## SUBJECT: Front Cab Mounting Squeak or Rattle

Department: Service  
 Section: Engine  
 Model(s): All  
 Model Year(s): 2011—2013  
 Effective Date: 9/14/2012  
 Form #: TSB CB-09  
 Rev #: n/a  
 Supersedes:

### CAB OR MOUNT SQUEAK

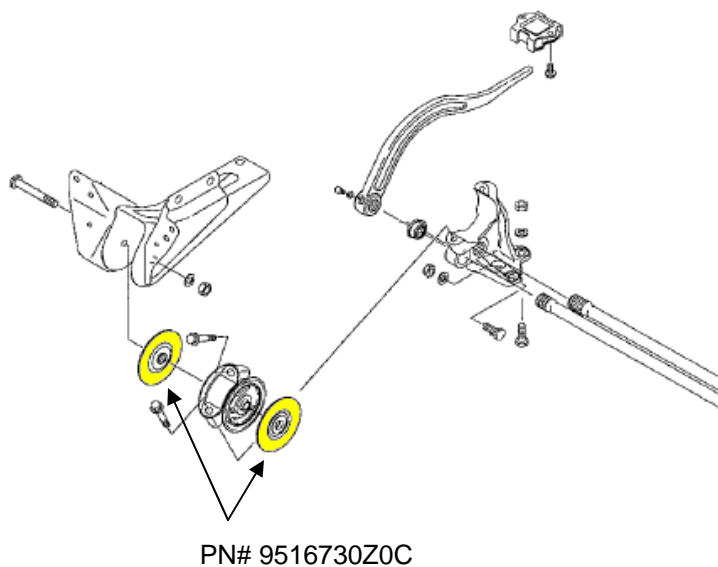
**Cause:** After cab installation on the chassis, there is an interference between the tilt-hinge housing and the side cushions.

**Correction:** Side cushions are produced with a revised polyester material with reduced friction and improved silicone lubricant beginning with the following 2013 MY VIN breakpoints.

Replace the side cushions at the tilt hinge with revised cushion PN# 9516730Z0C as illustrated below.

## CAB RATTLE

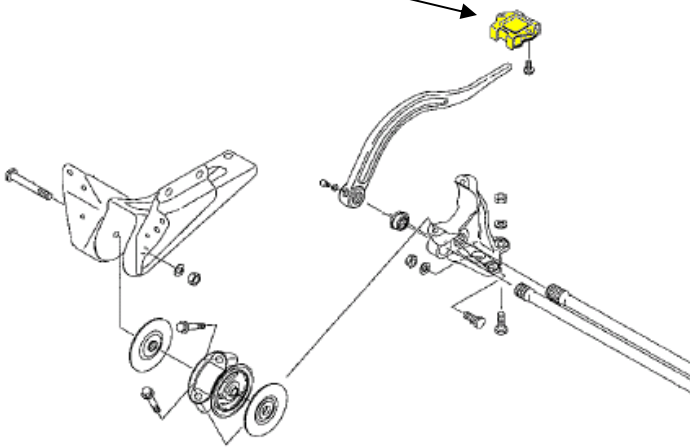
Cause: Insufficient clearance between the torsion arm and rubber contact seat.

Correction: A revised rubber contact seat with additional clearance was installed beginning with the following 2013 MY VIN breakpoints:

Replace the rubber contact seat at the torsion bar arm with revised cushion PN# 5020430Z0C as illustrated below.
